DEVELOPMENT APPLICATION ASSESSMENT REPORT

Application Number:	DA2023/0020
---------------------	-------------

This development application seeks consent for 'demolition work and change of use of site to an educational establishment (Stella Maris College) and installation of temporary demountable buildings for a period of 2 years.

Image 1- FSR calculation

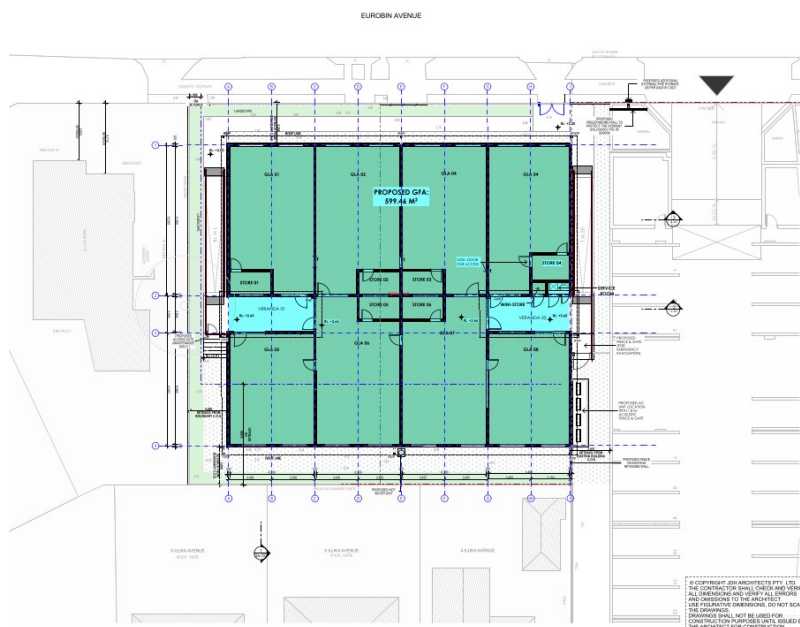
Description of non-compliance:

Development standard:	Floor space ratio
Requirement:	0.6:1 (558.78m ²)
Proposed:	0.69:1 (644.77m ²)
Percentage variation to requirement:	15%

The points raised by the applicant as environmental planning grounds are generally agreed with, in particular that the exceedance of the FSR is being supported on a temporary basis, with removal of this particular structure after 24 Months (which will be conditioned). It is agreed that there are no unreasonable impacts with regards to overshadowing, views or privacy for the adjoining sites. There is a need for the relocation of the students during construction on the main campus and the relocation of students to a site directly adjoining the school is considered reasonable and the most feasible approach to dealing with construction. The applicant has outlined that other options have been explored with regards to student relocation, with the current proposal the optimal outcome for the school, whilst having a temporary exceedance of the FSR control.

Therefore, the applicant's written request has adequately demonstrated that there are sufficient environmental planning grounds to justify contravening the development standard as required by cl 4.6 (3)(b).
